Boiler Room Equipment Replacement Carrillo Dining  
Commons Bldg. 562 and Santa Cruz Residence Hall  
Bldg. 548  
Project No. FM110338S/137-51  
**Addendum No. 01**

ADDENDUM NUMBER 1  
to the  
CONSTRUCTION DOCUMENTS

**AD1-MSK1**

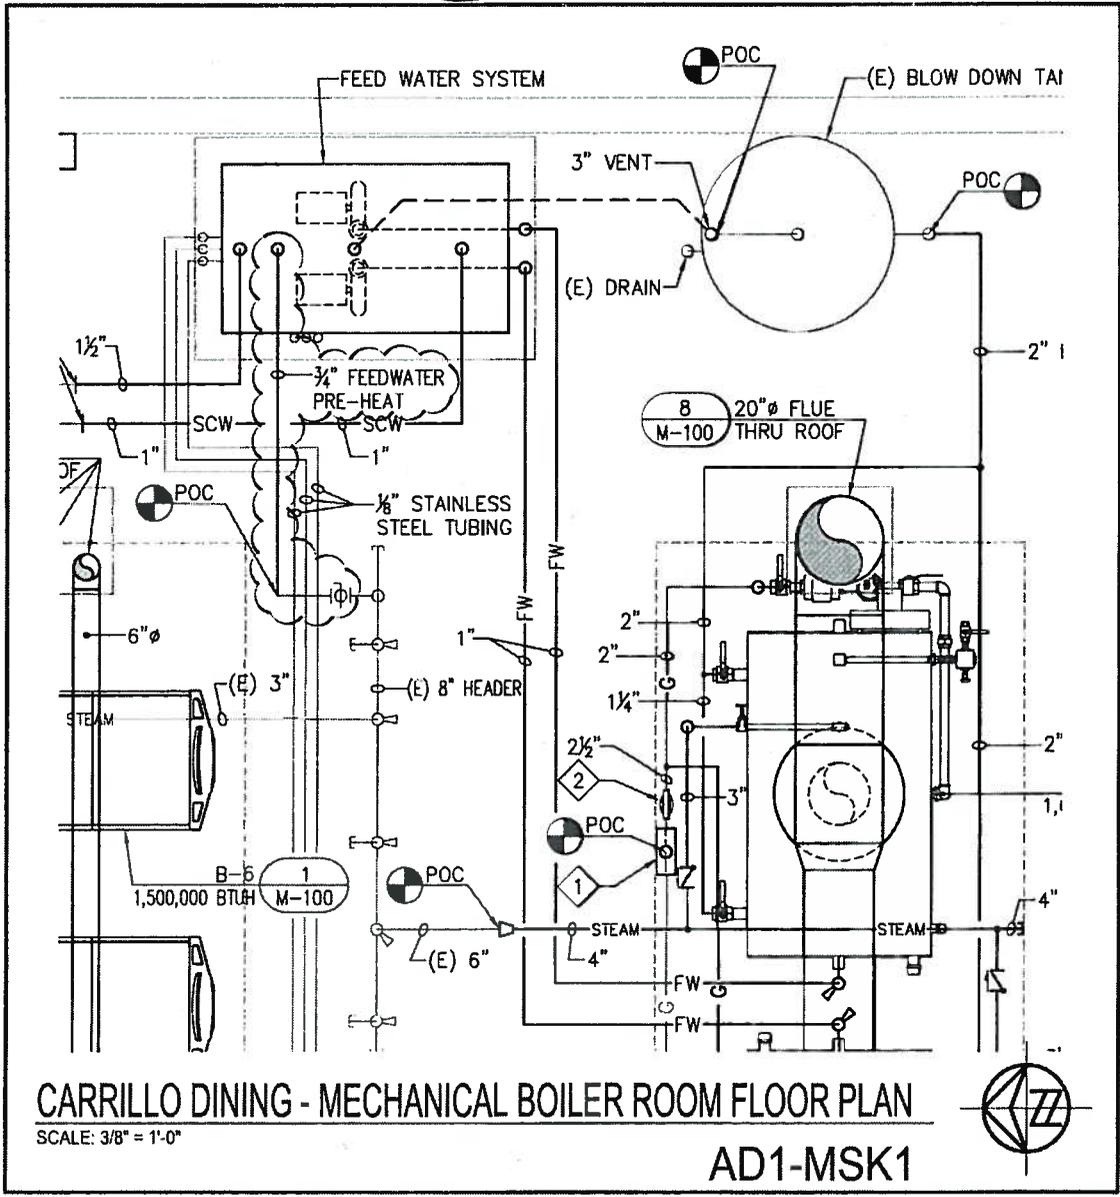
5. DRAWING NO. M-2.02, Carrillo Dining Commons: Size of steam line to feedwater tank is missing. See attached sketch AD1-MSK-1
6. DRAWING NO. M-1.00, Santa Cruz Residence Hall Pump Schedule – **Delete** Note 1 on CP-1 and CP-2.
